Planning Applications Committee

Wednesday 7th February 2018

ADDITIONAL INFORMATION

APPENDIX 1: AMENDED PLANS

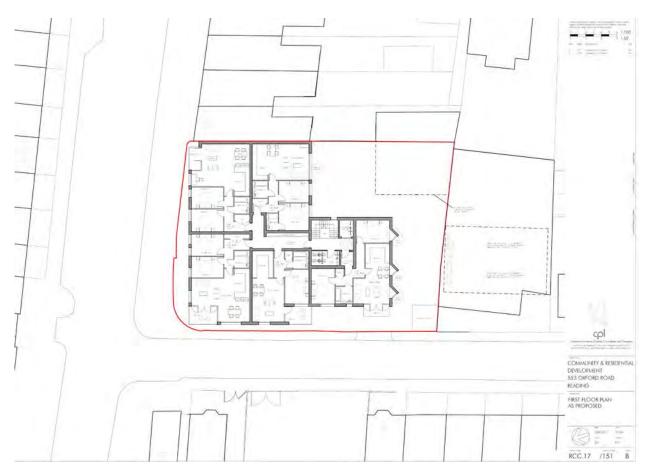
- 1.2 With regard to recommended reason 3, which relates to balconies and terraces at the upper floors to the rear, the amended plan removes the rear balconies to unit 5 (first floor) and unit 10 (second floor). This partially addresses this reason for refusal, so an amended reason is included in the recommendation above, which deletes reference to the balconies, but retains reference to the terrace.

- 1.3 With regard to recommended reason 4, which relates to rear facing windows, the amended plan shows windows on the rear elevation of units 1 (first floor), and unit 6 (second floor) with oriel windows, so that the line of view is towards Wilson Road. This is considered acceptable and it is recommended therefore that reason 4 be removed.

3. The raised terraces at upper floors to the rear would cause overlooking and the perception of overlooking, and loss of privacy, for surrounding residential properties, and would introduce amenity space at a height uncharacteristic in this area contrary to policy DM4.

Remove reason 4
